- END OF ELECTRICAL ADDENDUM NO. E-1 -

CLIENT	PUBLIC SERVICES AND PROCUREMENT CANADA		 <b>Goodkey Weedmark</b> <i>Consulting Engineers</i>
PROJECT	C1/C2 INTERIOR RENOVATIONS GROUND FLOOR - GOVERNMENT BUILDING		
TITLE	LIGHTING AND EXIT SIGN REVISIONS		1688 Woodward Dr. Ottawa Ontario Canada K2C 3R8
	DATE	DRAWN	SCALE
	2016-10-20	T.HOPKIN	1:100
	PROJECT No.	CHECKED	No.
	2015-481	J.MOFFAT	ADD-E1-SK1
		613 727-5111 Voice	
		613 727-5115 Fax	
		www.gwal.com Web

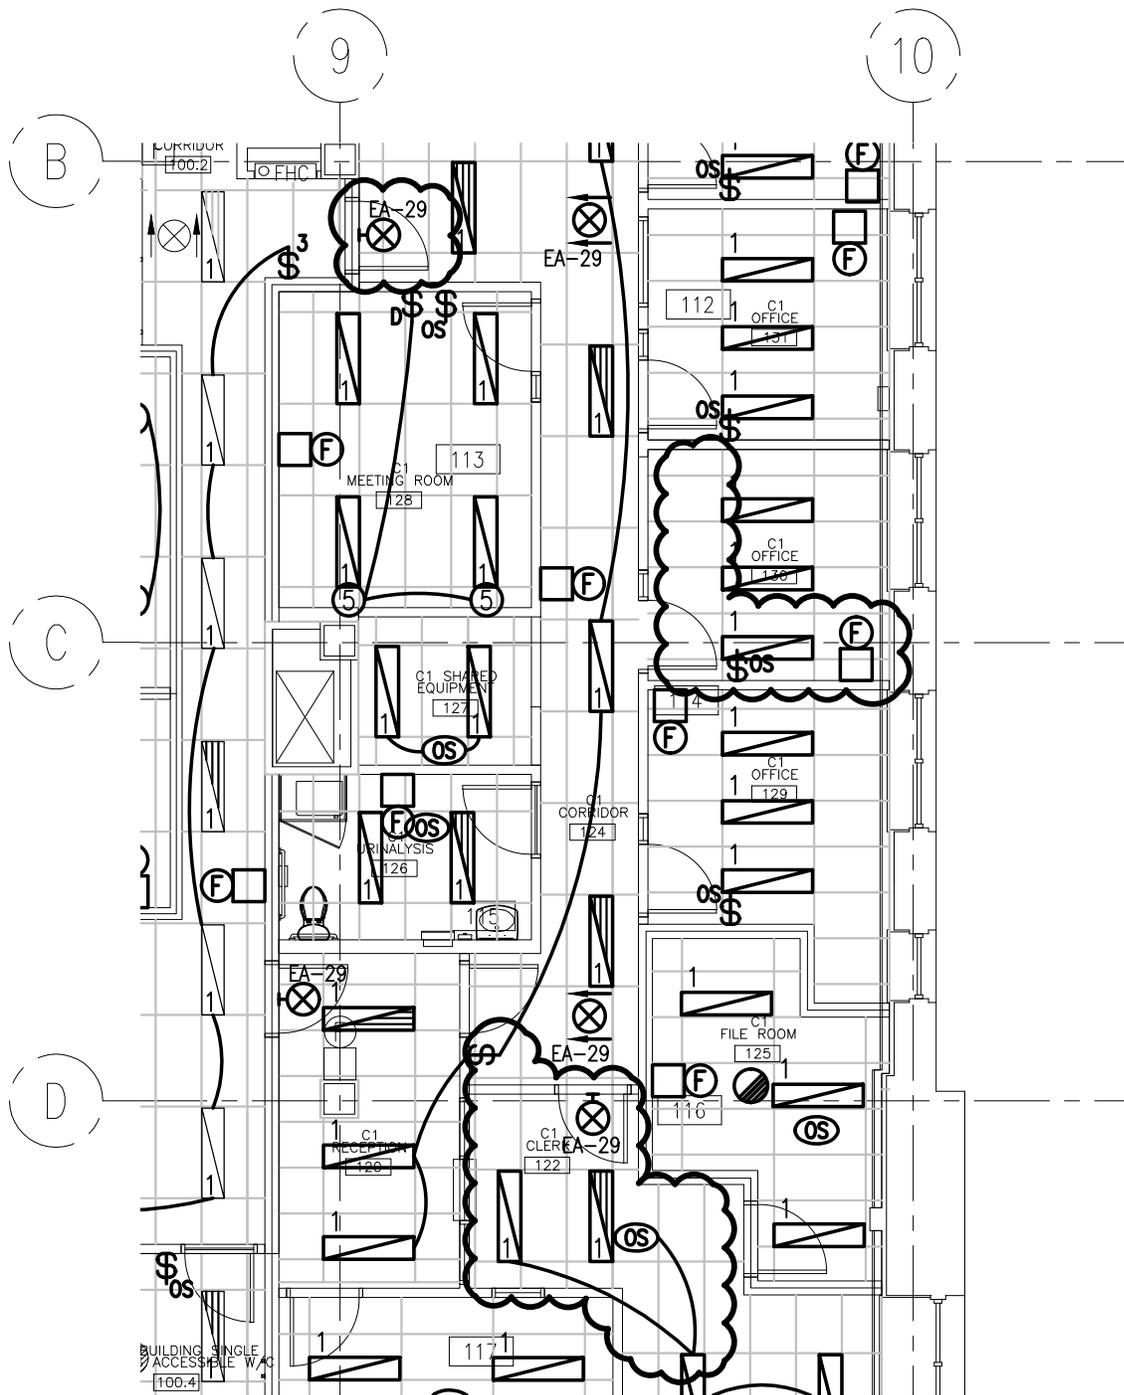
### **1. Reference Drawing E2 & Attached Sketches ADD-E1-SK1 & ADD-E1-SK2:**

- .1 Revise location of occupancy sensor in C1 Office 130 as indicated in attached sketch ADD-E1-SK1.
- .2 Provide exit sign in corridor C1 124 as indicated in attached sketch ADD-E1-SK1.
- .3 Provide one (1) additional Type 1 fixture at C1 Clerk Area 122 as indicated in attached sketch ADD-E1-SK1. Provide new exit sign and local ceiling mounted occupancy sensor and revise fixture wiring as indicated in attached sketch ADD-E1-SK1.
- .4 Revise lighting in Office C2 105 and Exam Room C2 103 as indicated in attached sketch ADD-E1-SK2.

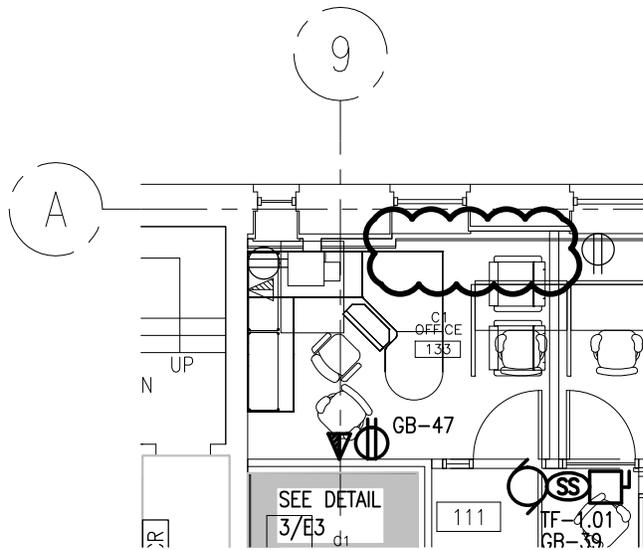
### **2. Reference Drawing E3 & Attached Sketch ADD-E1-SK3:**

- .1 Provide new 20A/120V circuit and rooftop maintenance 5-20R receptacle adjacent to new rooftop condensers on new C-channel frame at 750 mm above finished roof level. Provide weather-protective "while in use" cover for receptacle. Utilize panels in 3<sup>rd</sup> floor electrical room for new rooftop circuit.
- .2 Revise location of doorbell within CSC suite in accordance with architectural Addendum No. 2, item 1.7 and sketch ADD 2\_ASK 03.
- .3 Revise feeder for receptacles in server rack within C1 Server Room 134 to overhead feed. Install receptacles at standard height within server rack.
- .4 Revise Drawing Note 14 as follows:

"PROVIDE COMPLETE SOUND MASKING SYSTEM FOR CLIENT C2, INDICATED BY HATCHING. COORDINATE AND INCLUDE ALL NECESSARY COSTS AND ACCESSORIES FOR A COMPLETE WORKING SYSTEM. PROVIDE TWO (2) QUAD RECEPTACLES C/W TWO (2) 15A/120V DEDICATED CIRCUITS FOR SOUND MASKING SYSTEM AND INSTALL MAIN DRIVER WITHIN ELECTRICAL ROOM."
- .5 Delete telecommunication rough-in on east wall of office 133 as indicated in attached sketch ADD-E1-SK3.
